The City of New Brunswick

Re: 23 Duke Street (Soba College Recovery, LLC)
Block 62, Lot 49.01
Application PB-2020-17
Minor Site Plan Committee Review

7. Plan Review Comments

Looking north into the site from Duke Street, January 7, 2021

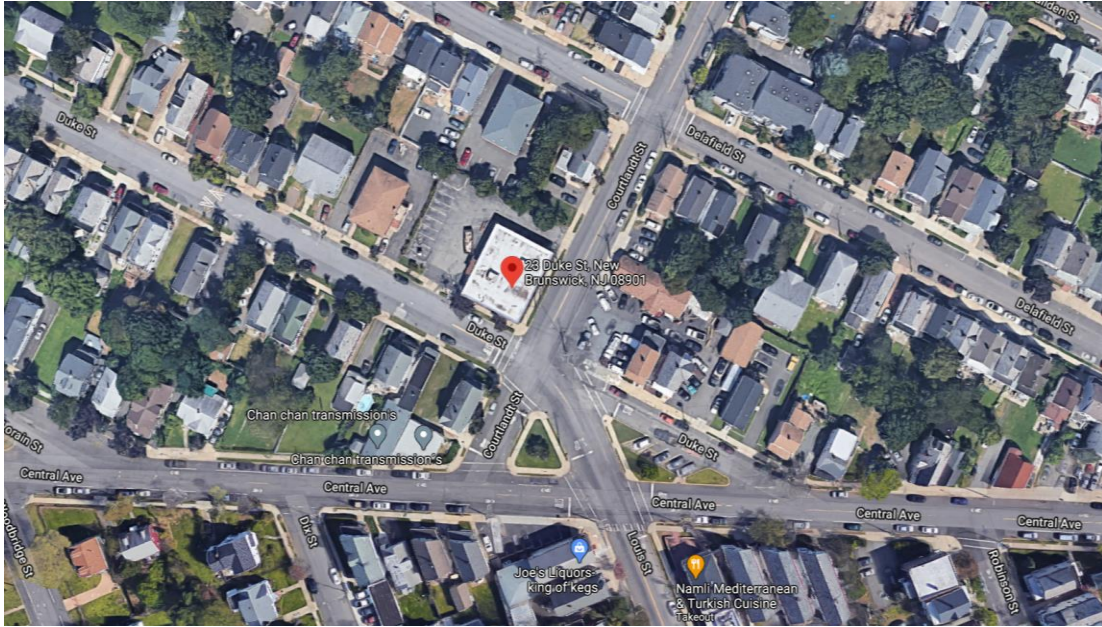
4. A board on board trash enclosure is shown on plans in the northwestern corner of the site. However, a site visit indicated that the dumpsters are stored in the parking lot area. The applicant should provide testimony as to how trash and recycling is managed on the site.
